Project:
MN2A

Title:
NMA Bay Study 01
Entrance

3.0 Drawing Register

The drawing register below shows the consented drawings on the left with the proposed replacement drawing on the right.

Proposed
Ground Floor Plan

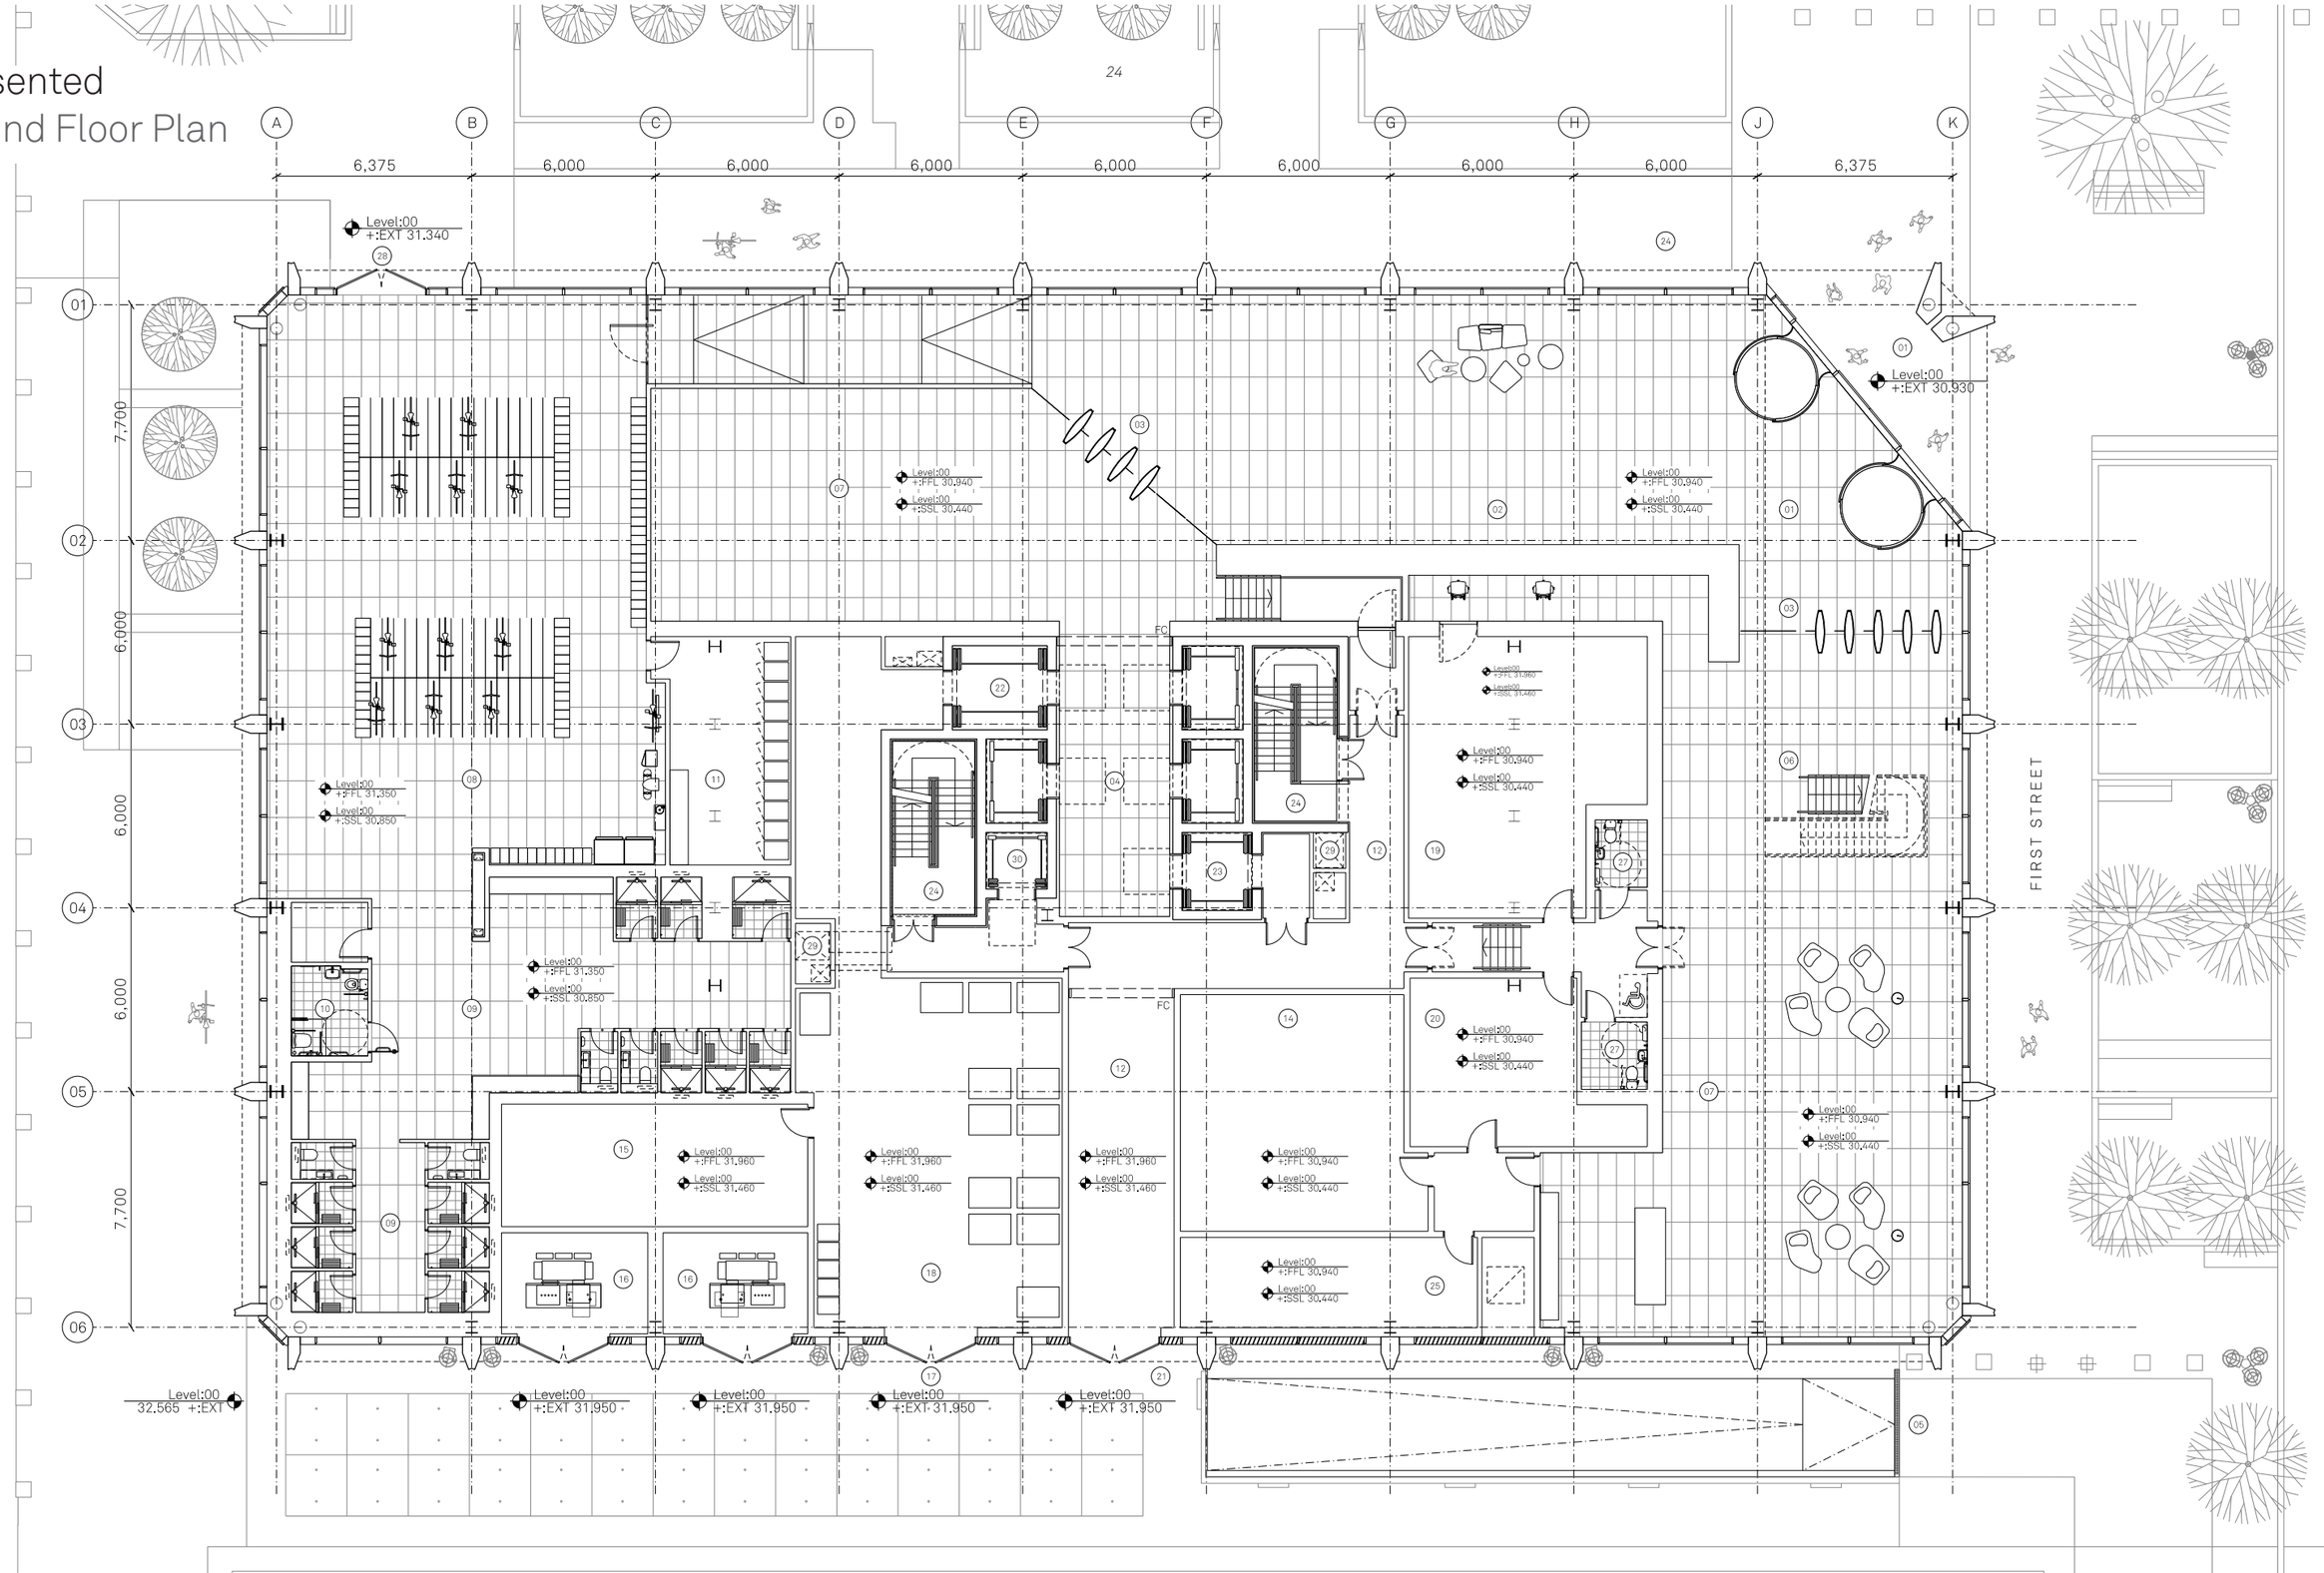
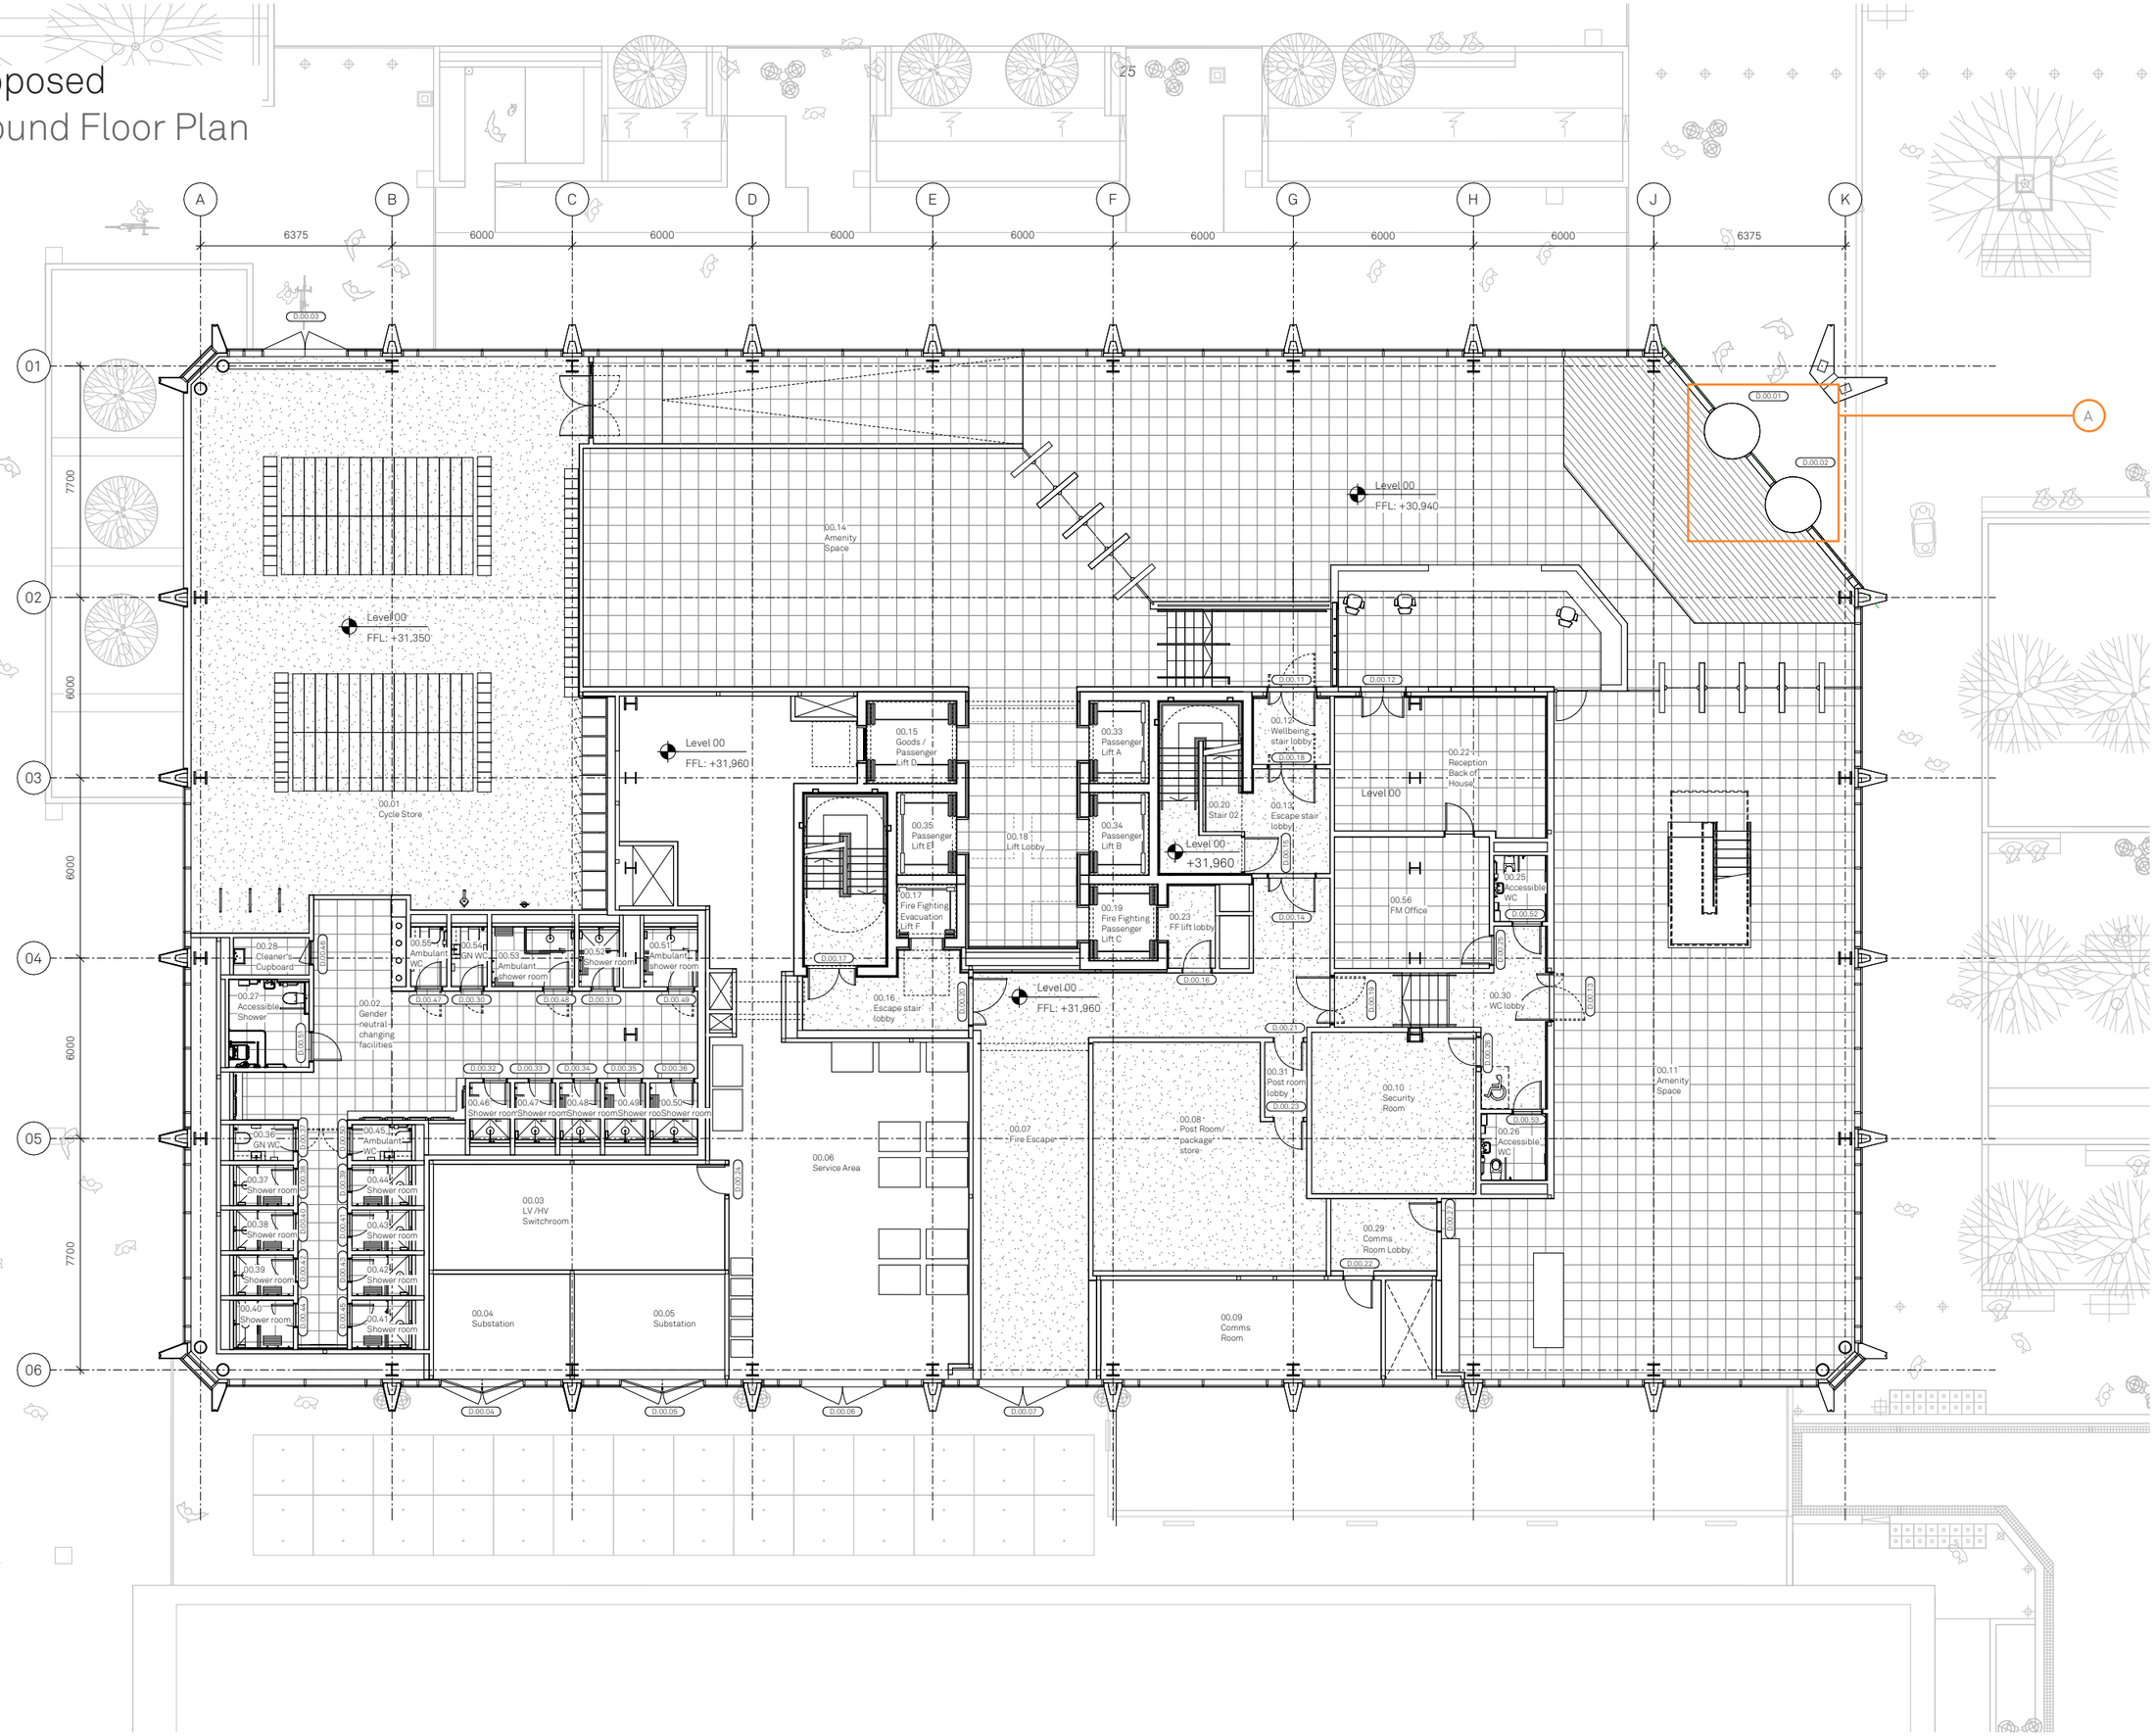
Rev:	Date:	Details:
P01	19/03/24	Issued for Planning
C03	18/03/24	Updated to TVR007, TVR011 and TVR013. Issued for Construction
C02	12/10/23	Doors, BoH stair & security room layout ammended. Bin store riser added to B&F requirements - Issued for Construction
C01	18/08/22	Issued for Construction - First Issue

Photo of balustrade proposal

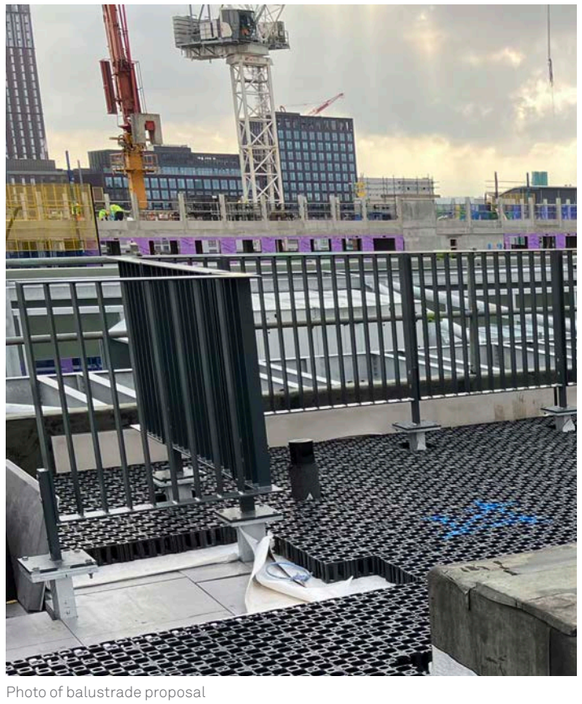
Proposed Change 1D

The plant to the highest roof level has been removed therefore the plant screen is no longer required. The proposed change is to install a metal balustrade in its place.

This metal balustrade would match the approved metal balustrade around the terrace a floor below on the facade line.

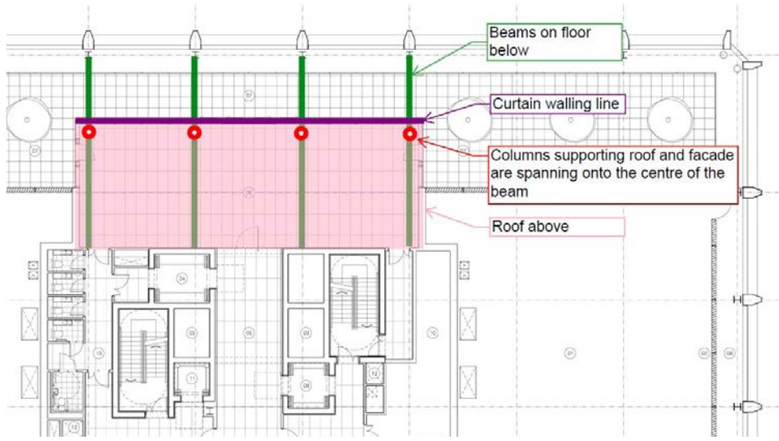
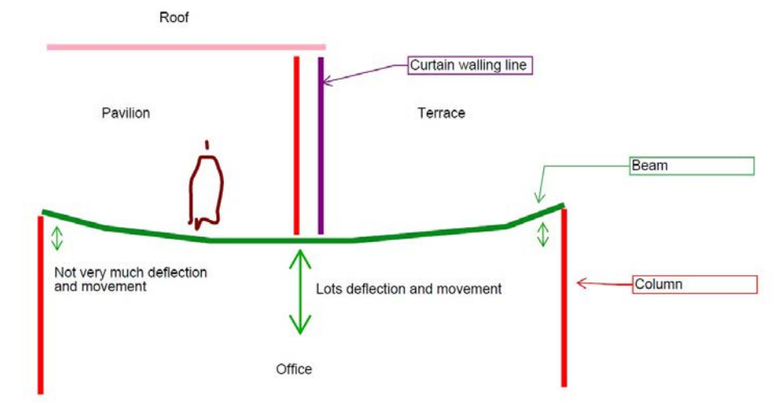
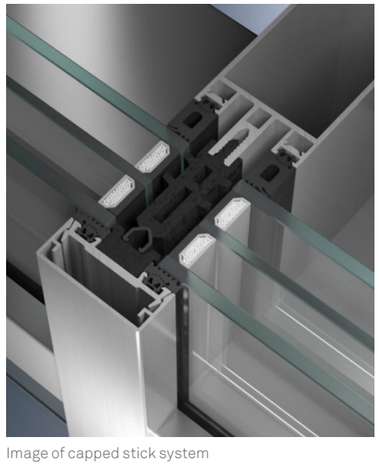
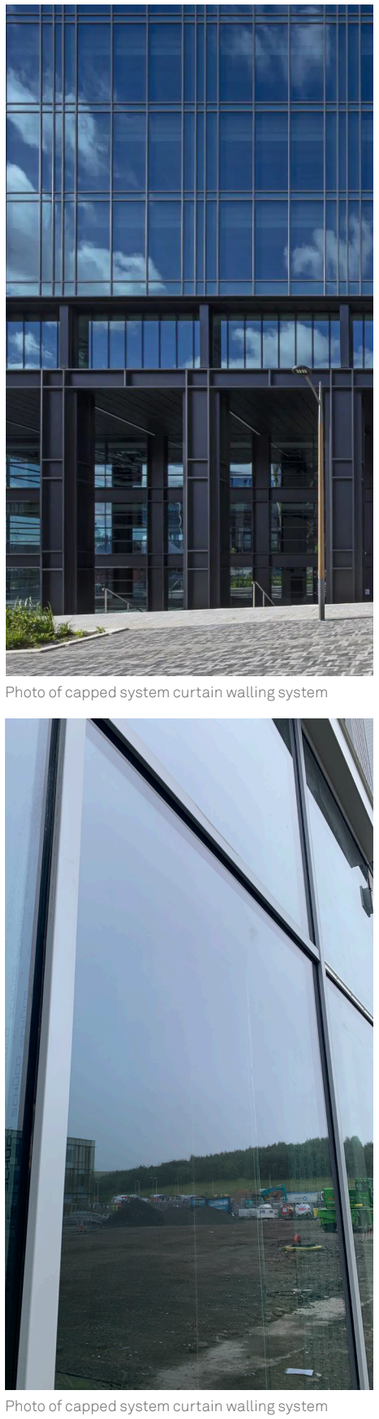
This change is required because the movement and deflections defined by with the structural design through detail design after planning submission could not be accommodated in a capless system whereas a capped system can accommodate additional movement.

However the long span steel beams on the floor below would have to be 200-400mm deeper and heavier to be more rigid to reduce the movement & deflection to allow a capless system than what was designed from pre planning through to construction and was only picked once the sub contractor came to design this element.

The photos below show the proposed capped system by the facade contractor on recent projects. Note the proposed caps for Plot 9a will be blue grey and anodised.

The proposed system is a Schueco system which is an industry leading system and the sight lines are 60mm which is narrower than a unitised system.

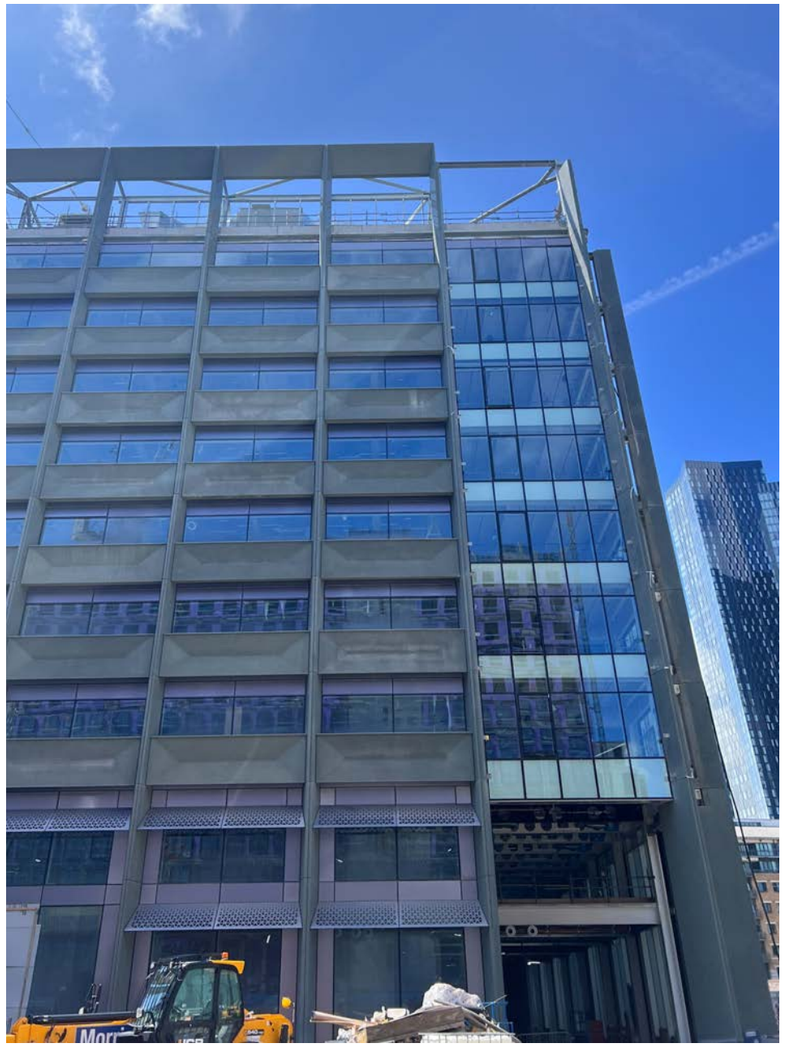
Proposed Change 3Q

The additional bracing has been added to stiffen the structure and reduce movement. The reduction in the movement of the structure allows the joints in the pre cast cladding panels to remain at 20mm as per the panels below. If the bracing were to be omitted the movement in the structure to which the cladding is fixed, would be more than the joint could accommodate and the joint would need to be wider.

The bracing has been designed to provide a regular rhythm which works with the building's order and provide a clear and legible structural diagram.
